Final Report - Corrections Required **Application No. DEPN-24-0160**

Description : Multi-family development with 170 rental duplex units on one development lot. Also a request for alternate landscape compliance related to placement of streamside overly and property boundary buffer plantings, and to be allowed to provide 9.4% active open space where 10% is required.

Document Filename : Cottages at Kettle Creek DP_1st_Submittal_101524.pdf

COTTAGES AT KETTLE CREEK

COVER SHEET

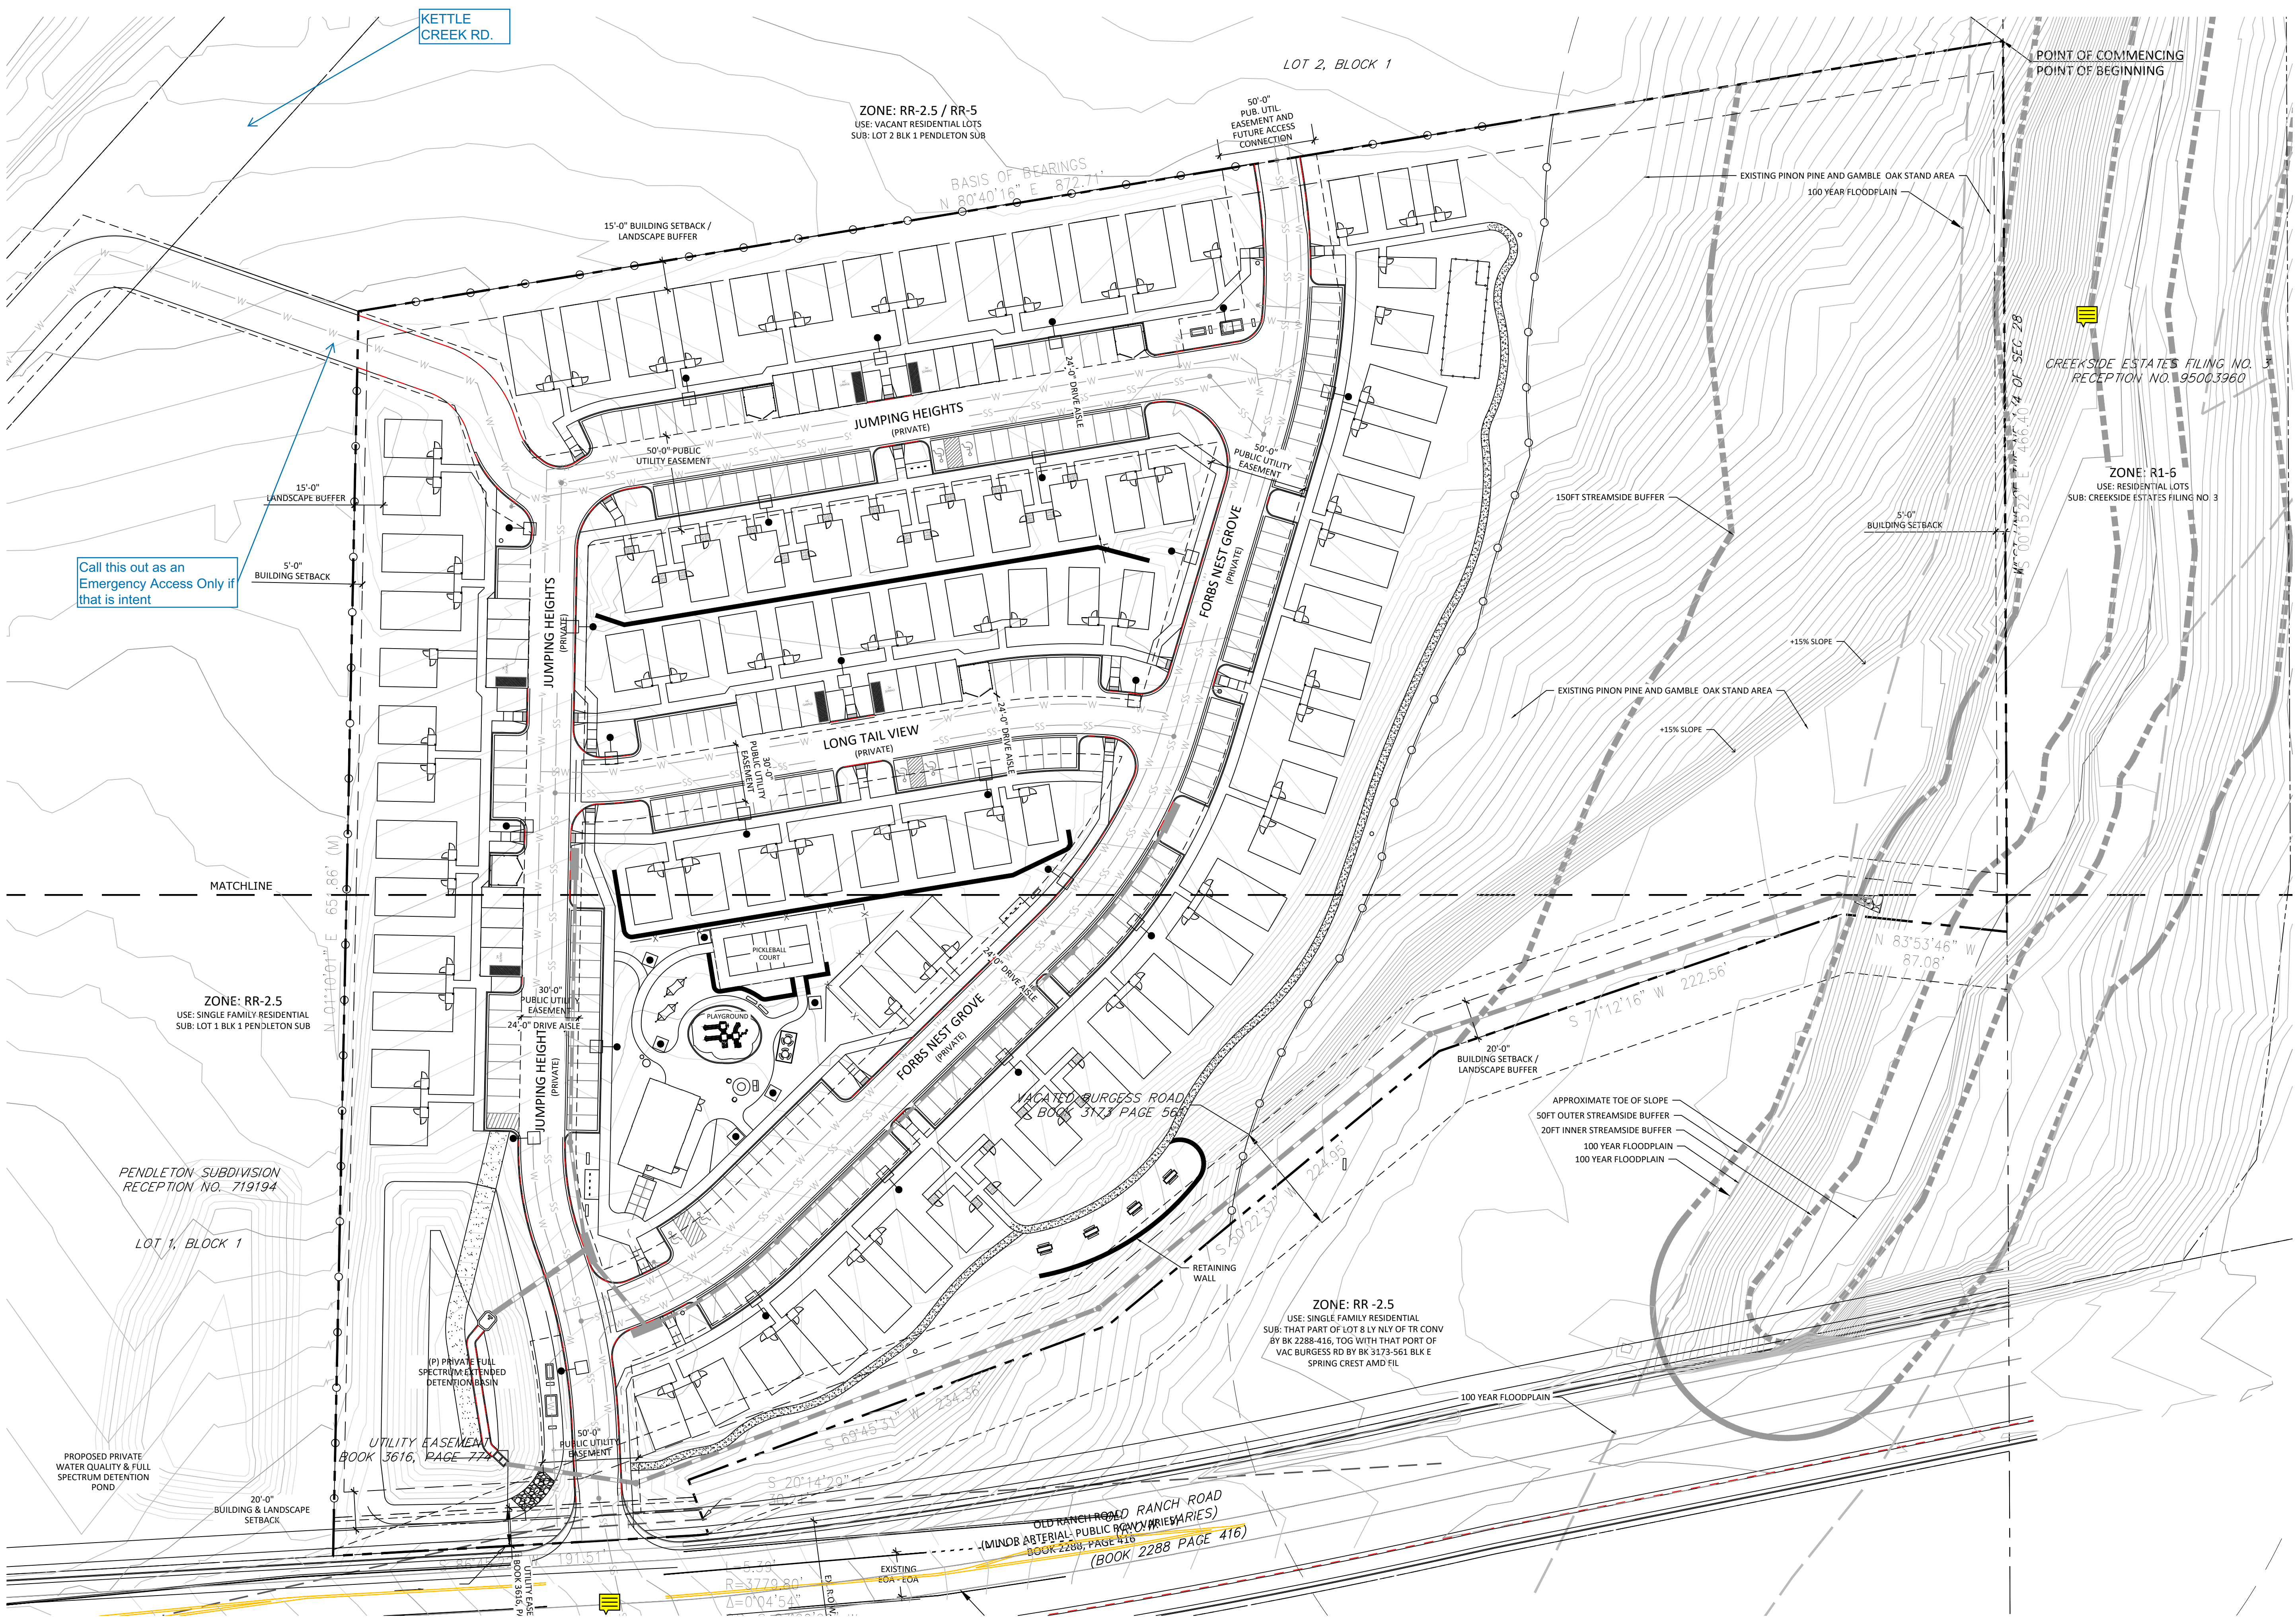
Include the Plat title in the title or cover sheet of the Development Plan.

SITE PLAN

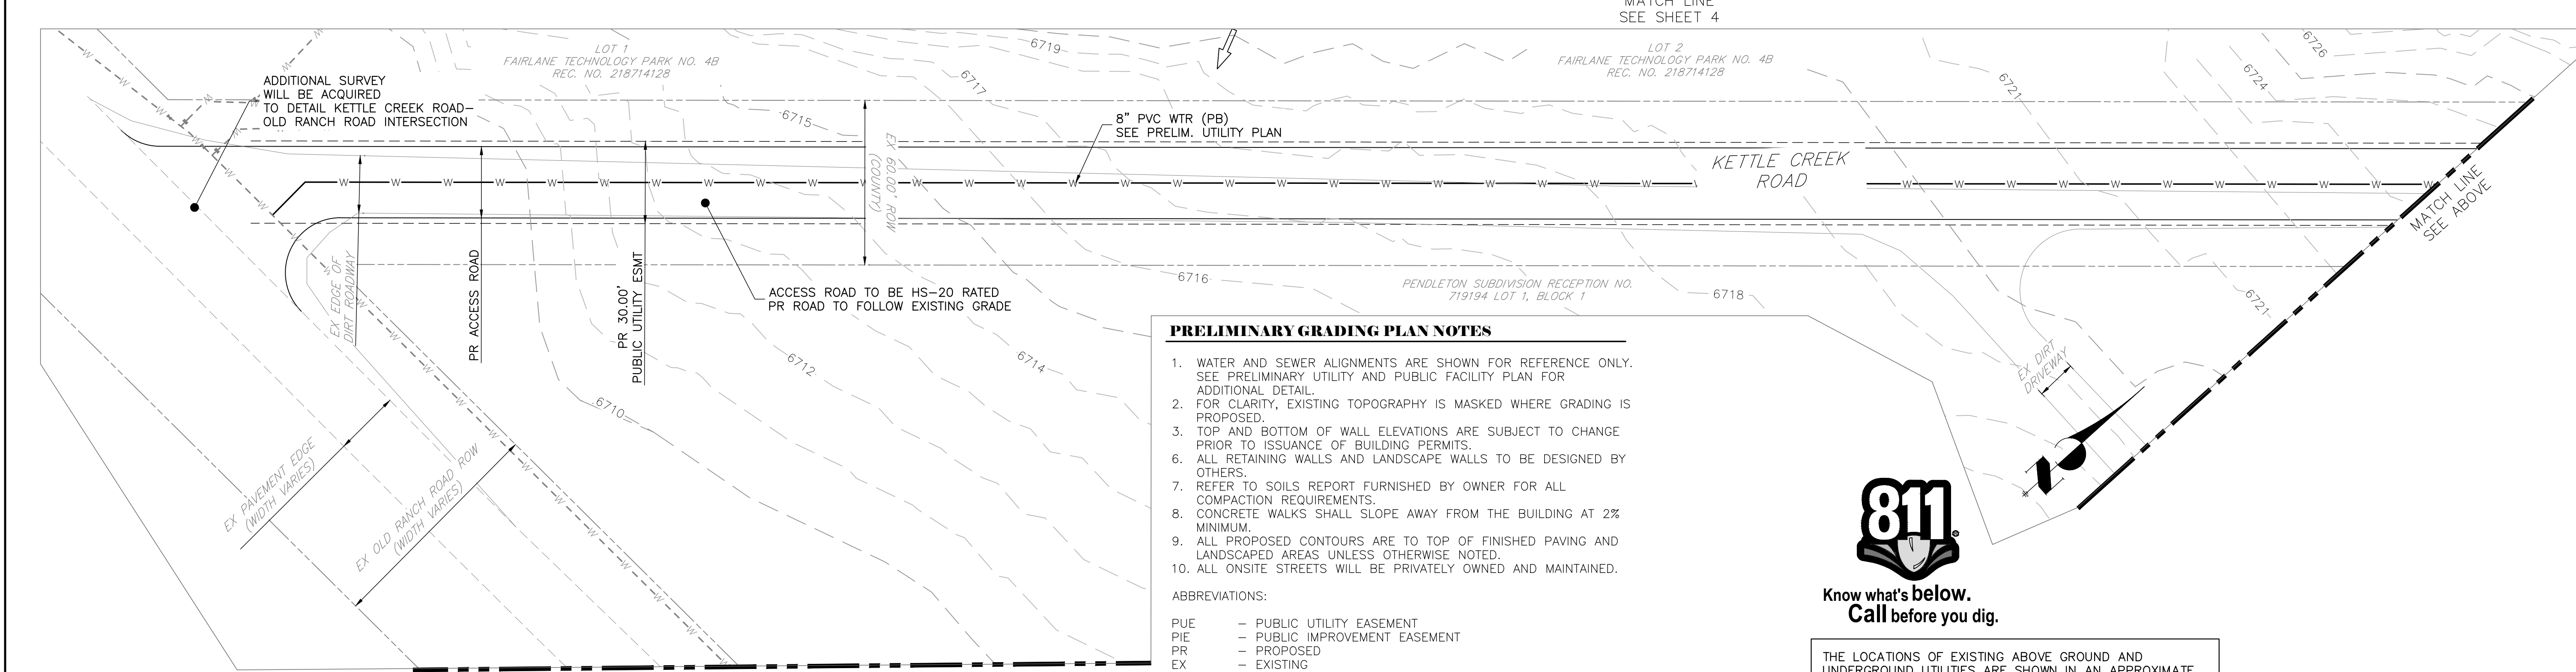
Call this out as an Emergency Access Only if that is intent

JOB NO: 24026 LOCATION: COS
 COTTAGES AT KETTLE CREEK
 PRELIMINARY GRADING PLAN

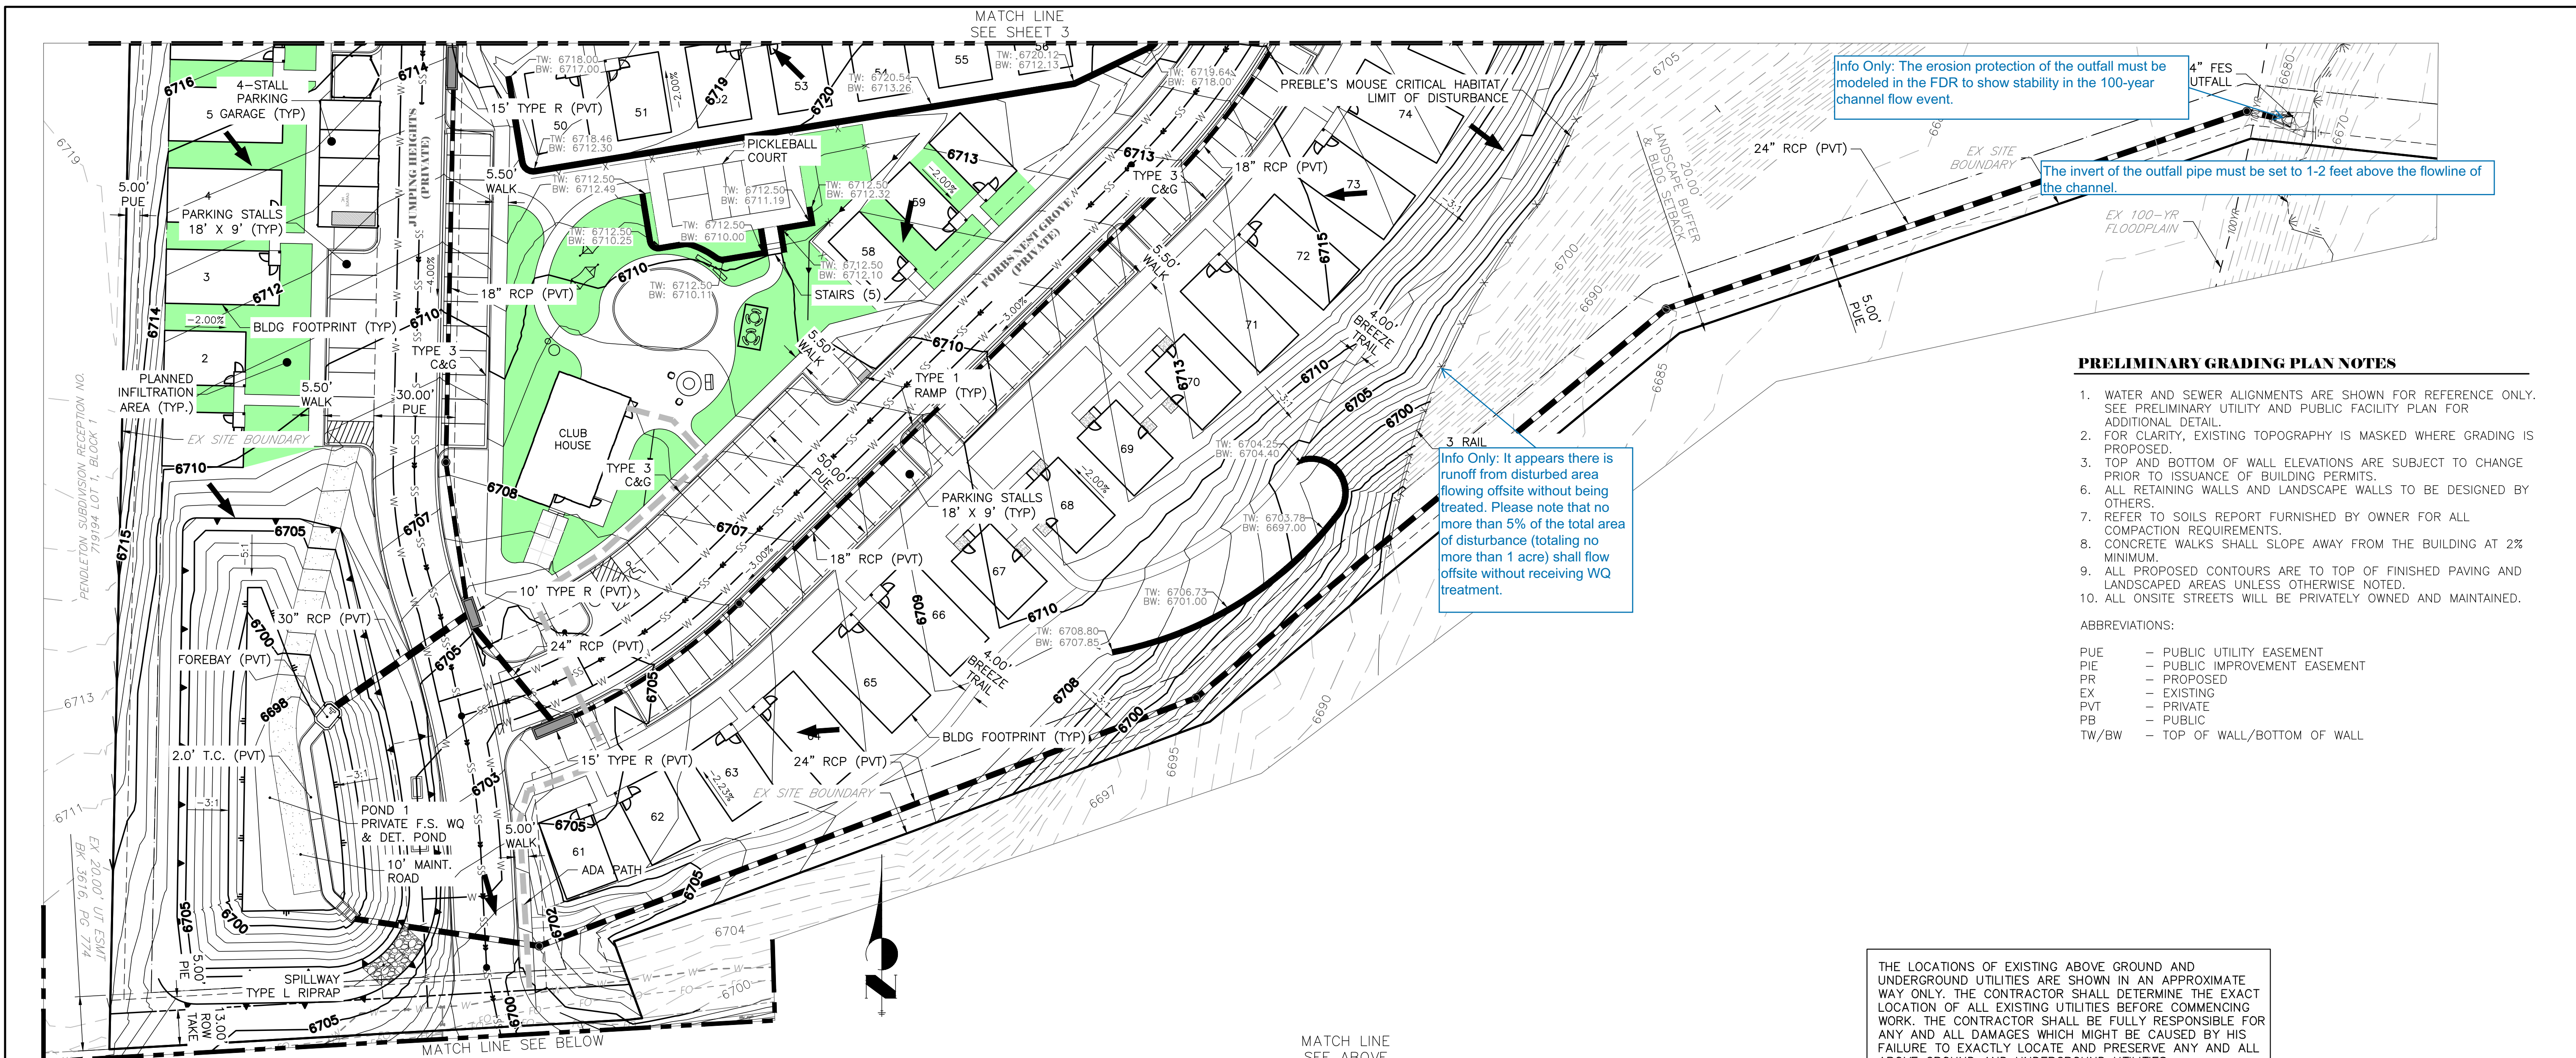
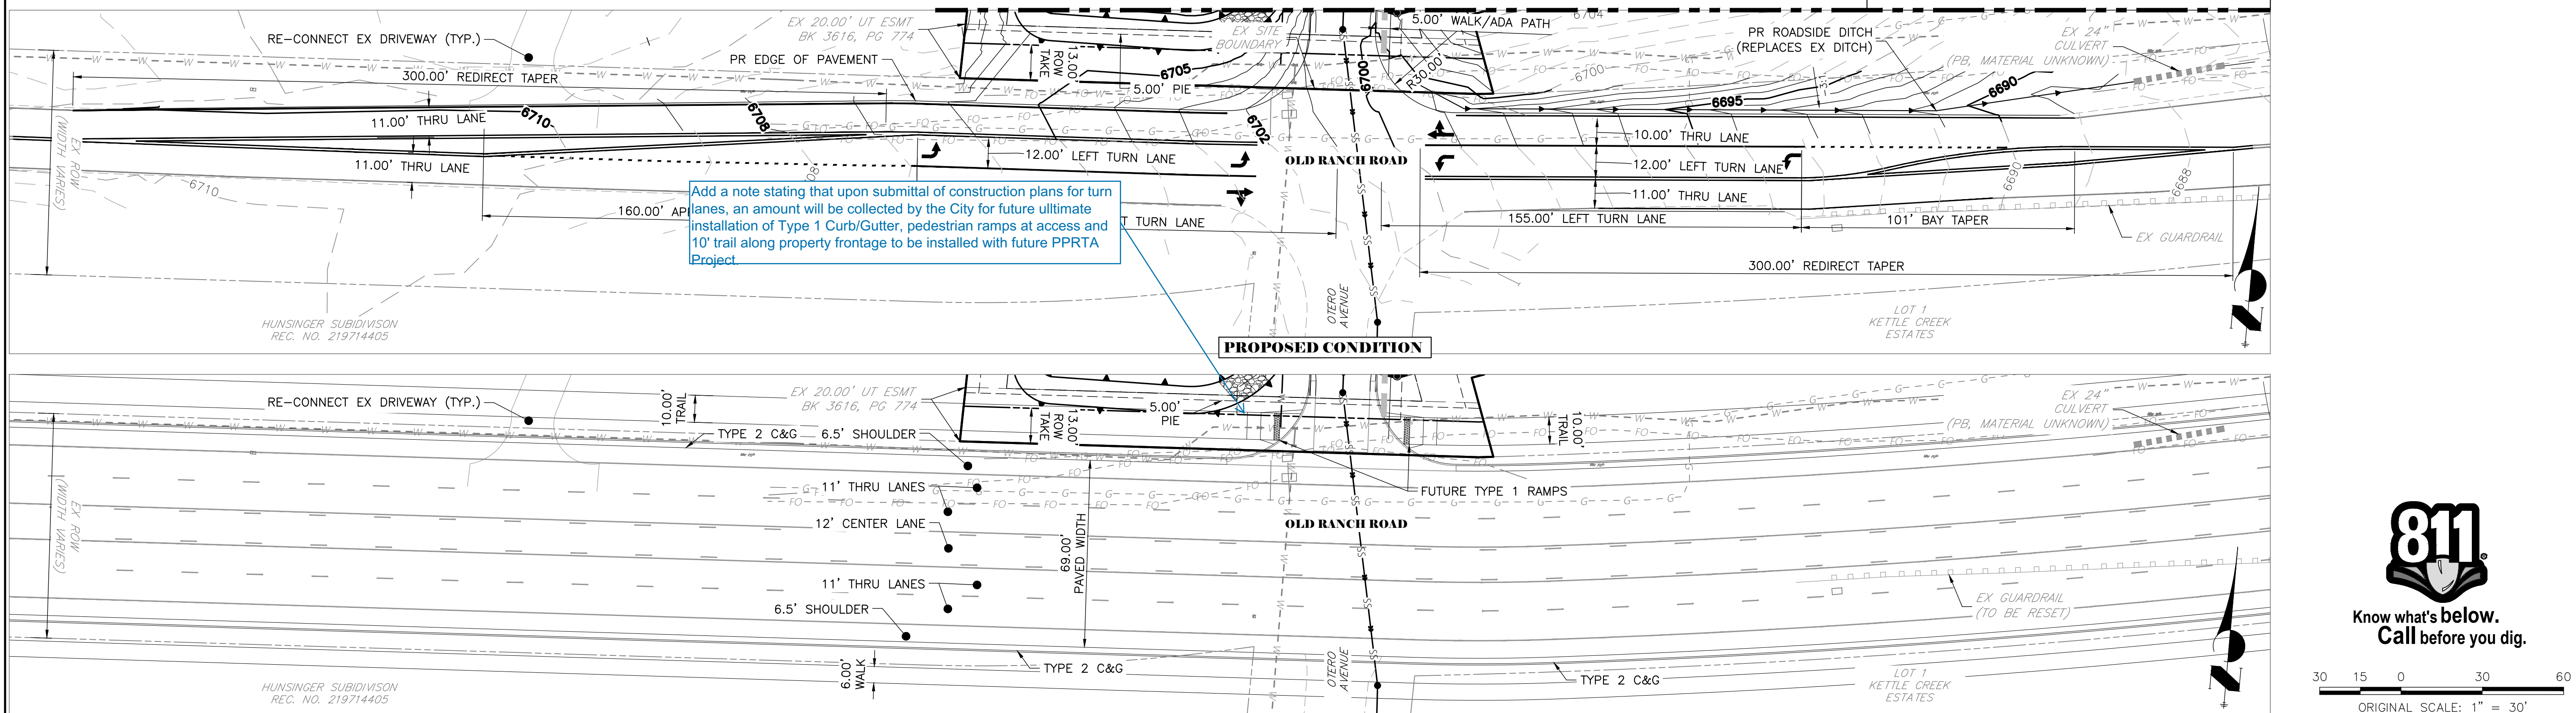
Info Only: The erosion protection of the outfall must be modeled in the FDR to show stability in the 100-year channel flow event.

The invert of the outfall pipe must be set to 1-2 feet above the flowline of the channel.

Info Only: It appears there is runoff from disturbed area flowing offsite without being treated. Please note that no more than 5% of the total area of disturbance (totaling no more than 1 acre) shall flow offsite without receiving WQ treatment.

Add a note stating that upon submittal of construction plans for turn lanes, an amount will be collected by the City for future ultimate installation of Type 1 Curb/Gutter, pedestrian ramps at access and 10' trail along property frontage to be installed with future PPRTA Project.
